**SERVICE BULLETIN 0511-002**  
11-25-2005, Revision IR

## **BOOST CUTOFF SHAFT BUSHINGS**

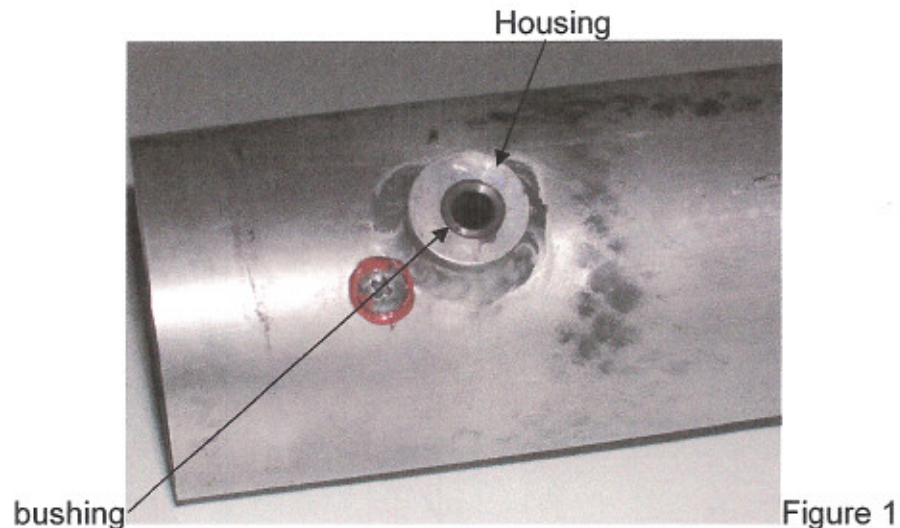
Several instances of wear have been observed in the bushings on the boost cutoff valve shaft. The suspected cause of the wear is vibration. The wear causes the bushings to become oval where they contact the shaft. While the wear causes no operational difficulty, the condition must be addressed before the bushings wear through to the housing and damage results to the supercharger duct and/or the shaft.

1. Inspect the boost cutoff valve shaft for radial play and ensure the bushings are not worn out of round. The bushing on the back side can be checked with a mirror. There will always be some wear over time, however: if the bushing is worn more than half way to the outside edge of the bushing (figure 1), replace the bushing. Release the butterfly valve by removing the two screws that hold the valve to the shaft and remove the valve and shaft. Extract the bushing from the supercharger duct and replacing it with Cessna P/N 0532104. After pressing the new bushing in, cut it flush with the outer surface. Replace the shaft and valve using new MS24693S26 screws. Use blue threadlock on the screws and peen the exposed threads. (If the bushing is worn less than half way through, go to step 4).

Figure 3

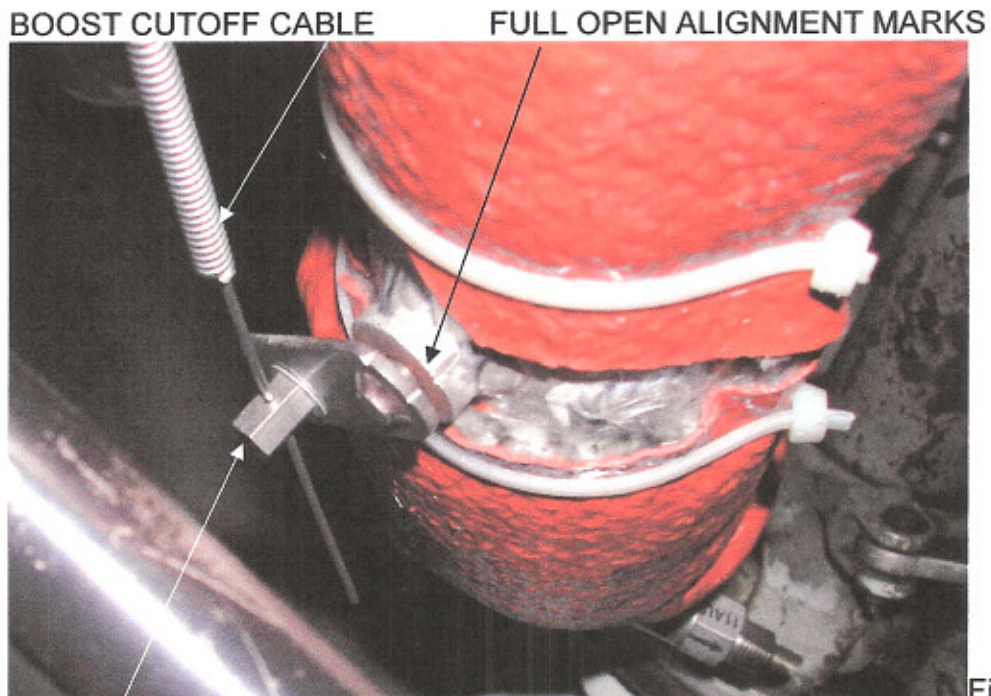
3. After making sure that the Boost Cutoff control is in the full forward position, align the marks on the valve shaft and the shaft housing and tighten the attachment bolt on the cable. The valve lever will have moved downward and be approximately 45° to the supercharger duct. The butterfly valve will be in the full open position (figure 3).

Figure 4

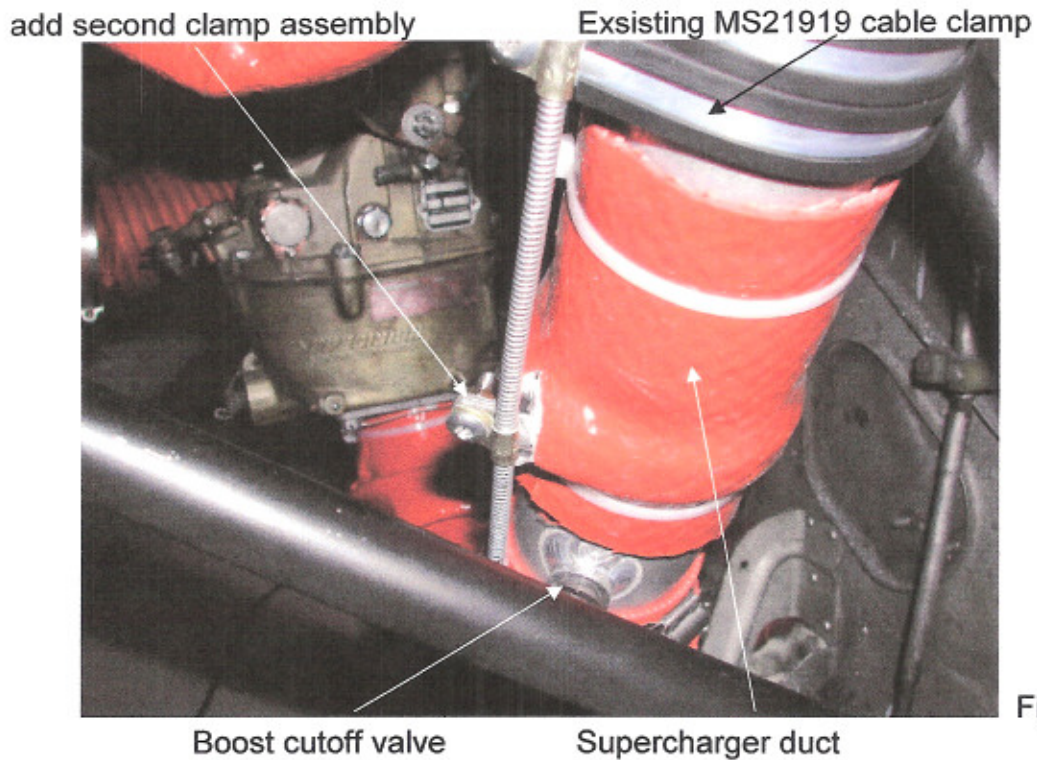
4. Install a second clamp assembly on the boost cable as close as possible to the boost cutoff valve (figure 4). The second clamp assembly is made from an AN742-D3 and an MS21919 DG40 clamp, the same as the existing cable clamp. Check for smooth operation of the boost cutoff cable.
